Site:- **SUMMER LANE PAGHAM**

Drawing Title:- **SuDS FEATURES CONTROL CHAMBER CONSTRUCTION DETAILS**

Drawing No. **DSM/E4761/435 A**

Control Chamber Detail SW-2

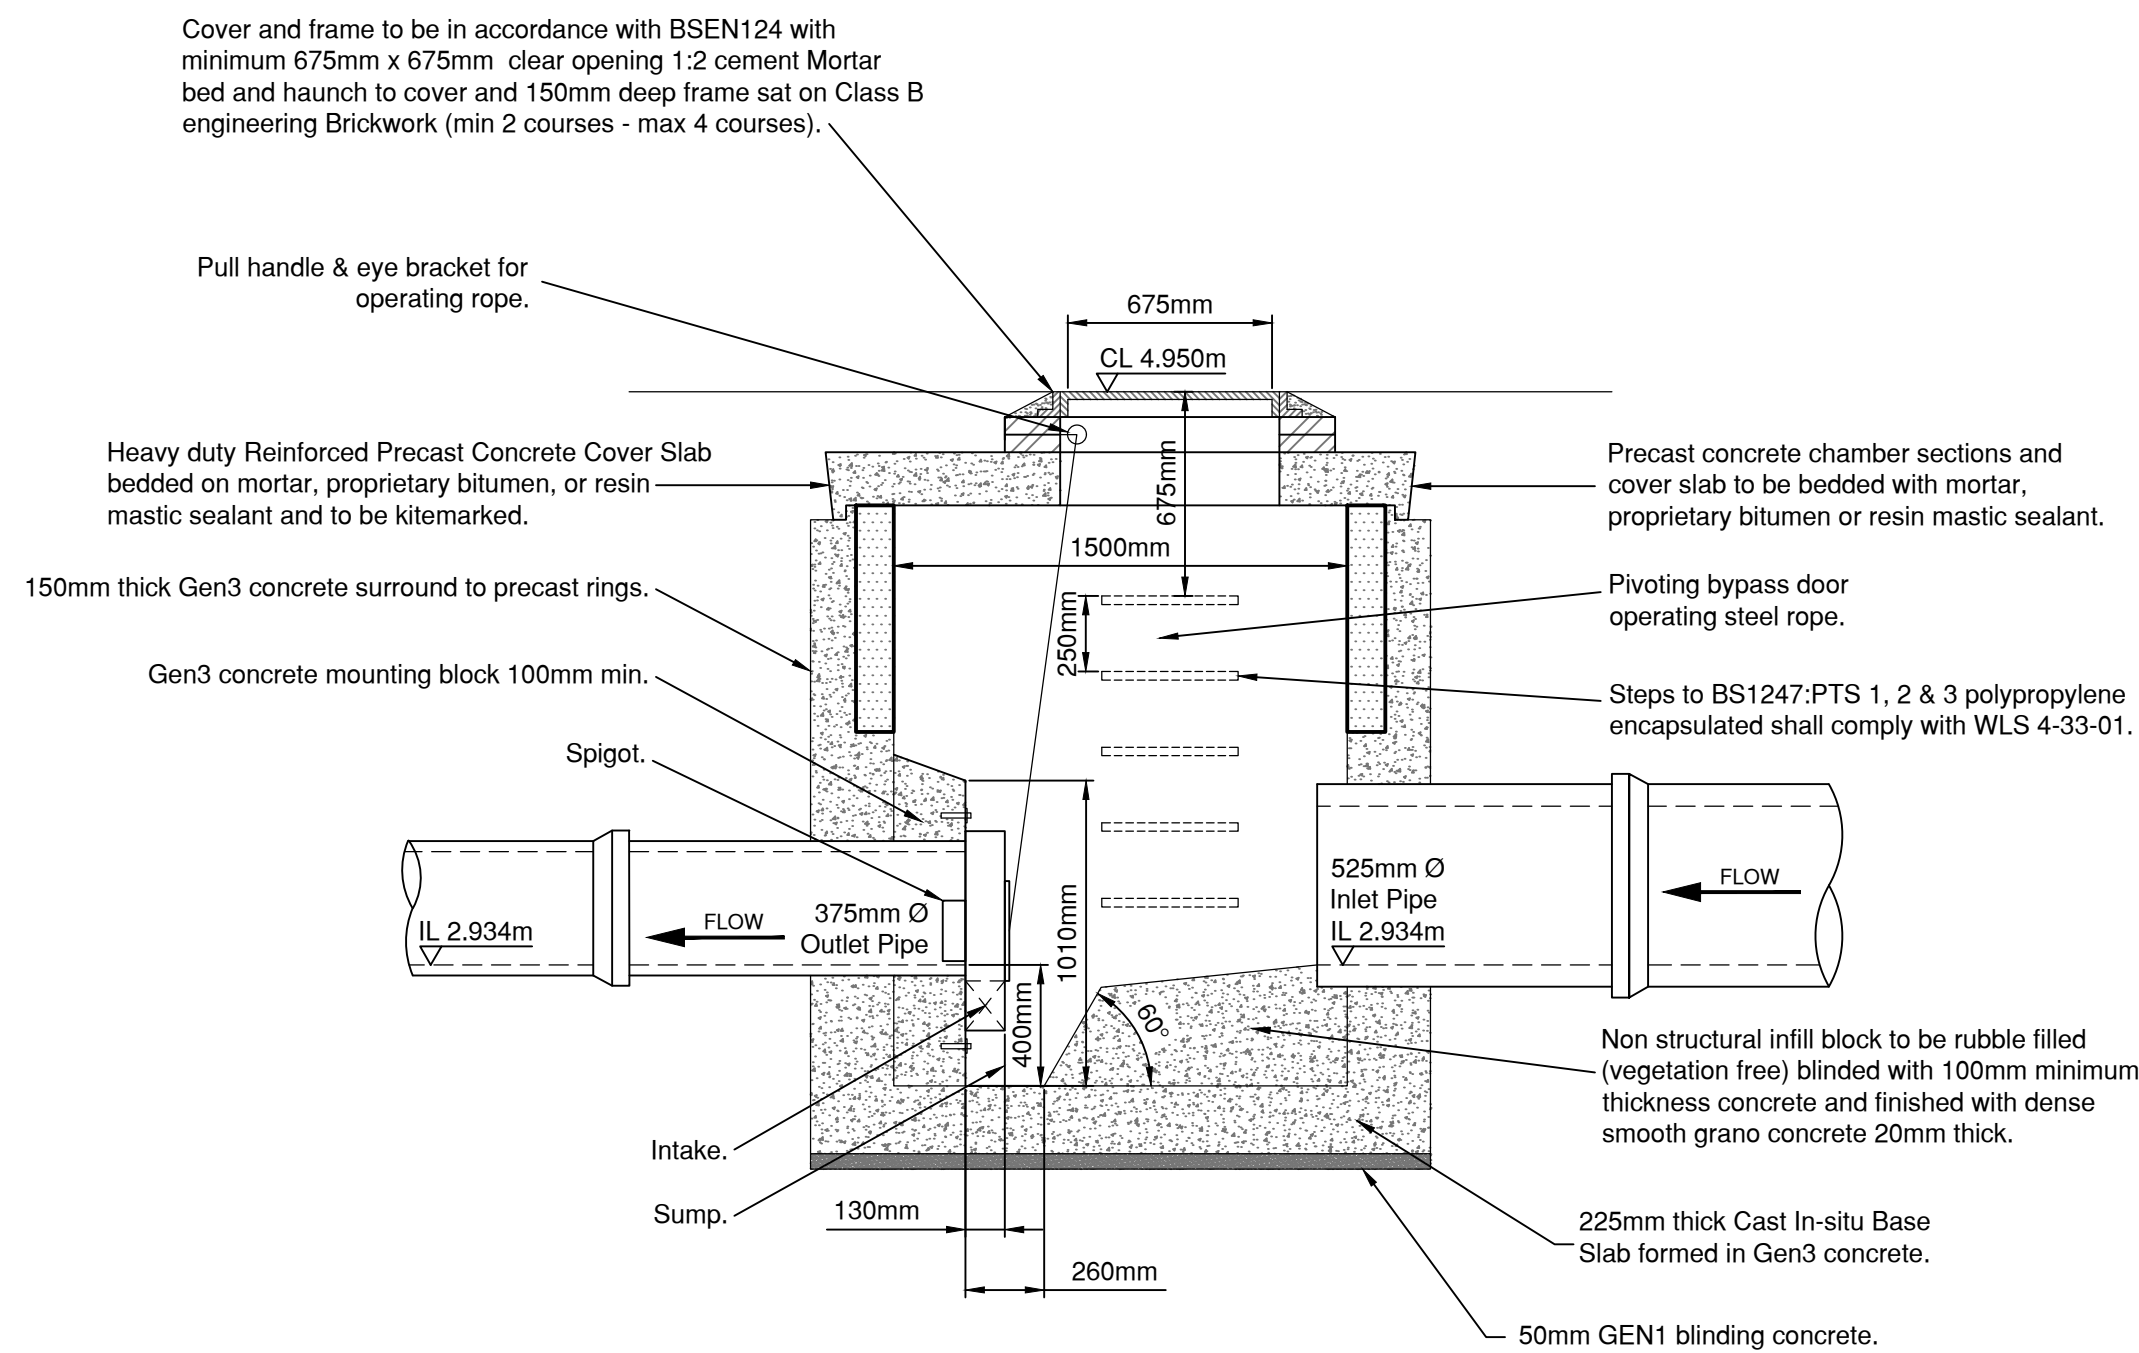
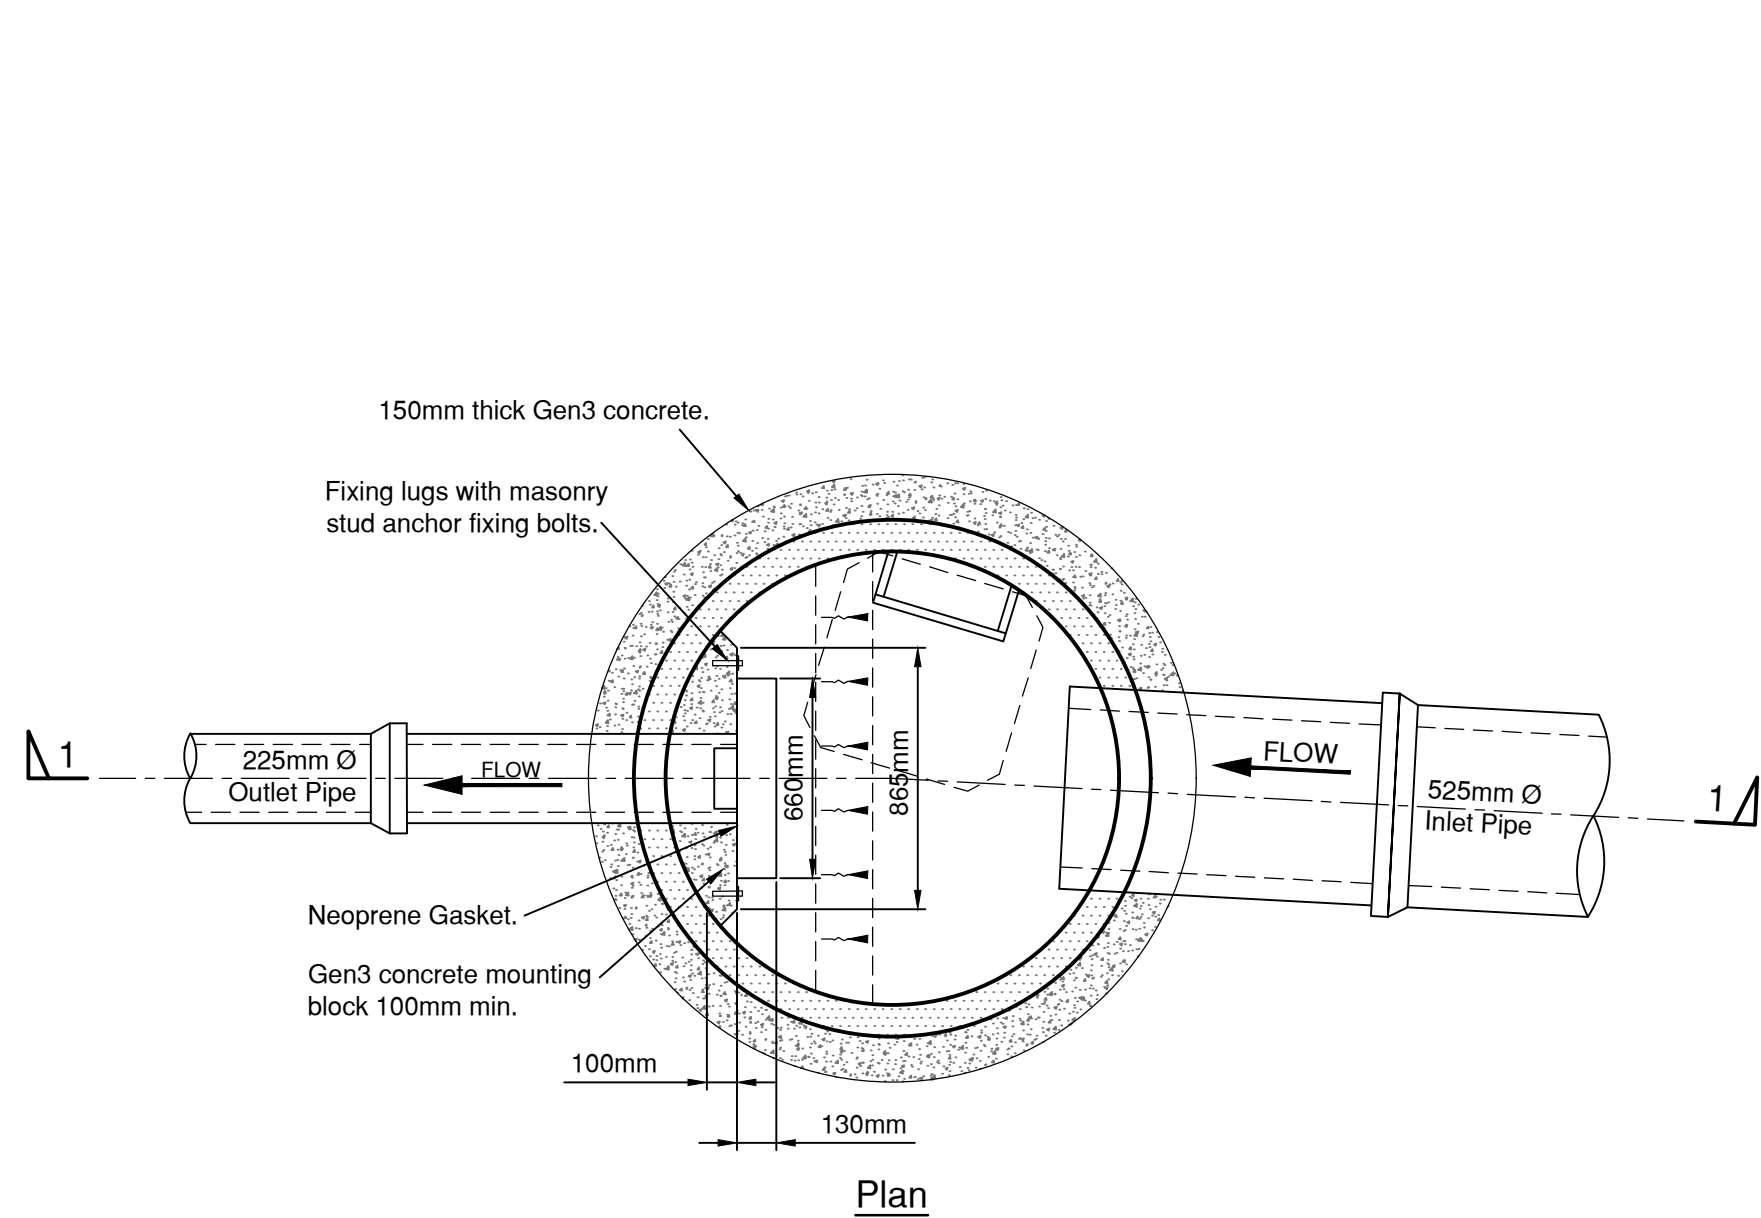
Rev.	Date	Details	By	Chkd	Appd
A	03.07.20	Pull handle and eye bracket relocated above hydrobrakes. SW-2 invert and outgoing pipe size revised in accordance with comments received from Arun District Council 23/06/2020. (Revision clouds omitted for clarity).	LD	TK	TRS
